**ANNEX E
TECHNICAL REVIEWS**

**Central Everglades Planning Project, Florida
Post Authorization Change Report
(Integrated Feasibility Study and Draft Environmental Impact Statement)**

**CENTRAL EVERGLADES PLANNING PROJECT
POST-AUTHORIZATION CHANGE REPORT**

Bridges: The following items of concern are found Bridges B-1, B-2 and B-3.

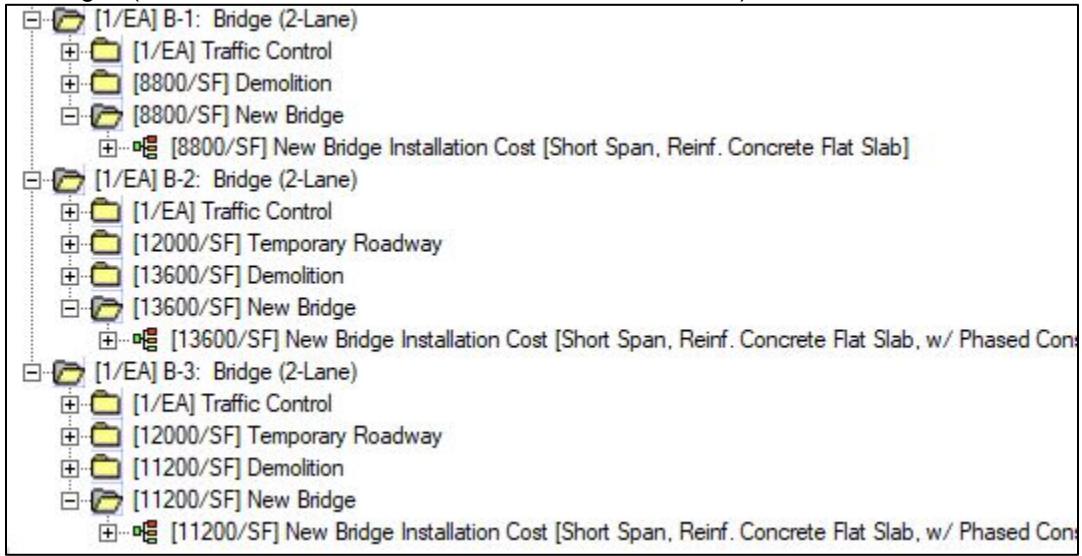
- Bridges (Below is the MII estimate and QTOs should match.)

- QTO lists 3 bridges, all 200 ft long, but of varying roadway widths.
- QTO lists all 3 bridges as 2 lane.
- MII reflects 3 bridges having varying deck areas
- MII reflects all 3 bridges as 2 lane
